PREDETERMINATION SETTLEMENT AGREEMENT

CP# 10-16-69672
HUD# 07-17-5293-8

Harlocke consists of a residential-unit building located at 915 Harlocke Street. All of the dwelling-unit buildings and common areas are required to meet the accessibility requirements of the ICRA and FHA.

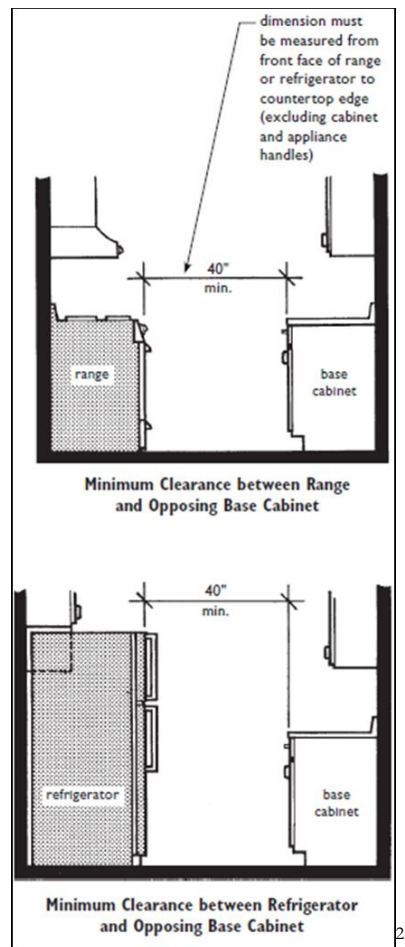
(a) The parties agree the distance from the midline of the range to the nearest obstruction in Units 5, 7, and 10 – as reported on pages 4 and 5 of the current agreement – was measured at less than the 24-inch minimum required by the Manual and ANSI 2003.

(b) Owners agree to move the base cabinet adjacent to the range, and then move the range further away from the nearest obstruction to increase the distance from the midline of the range to the nearest obstruction to no less than 24 inches in Units 5, 7, and 10 to meet the 24-inch minimum distance as required in the Manual and ANSI 2003. Owners agree to complete this work by August 15, 2018.
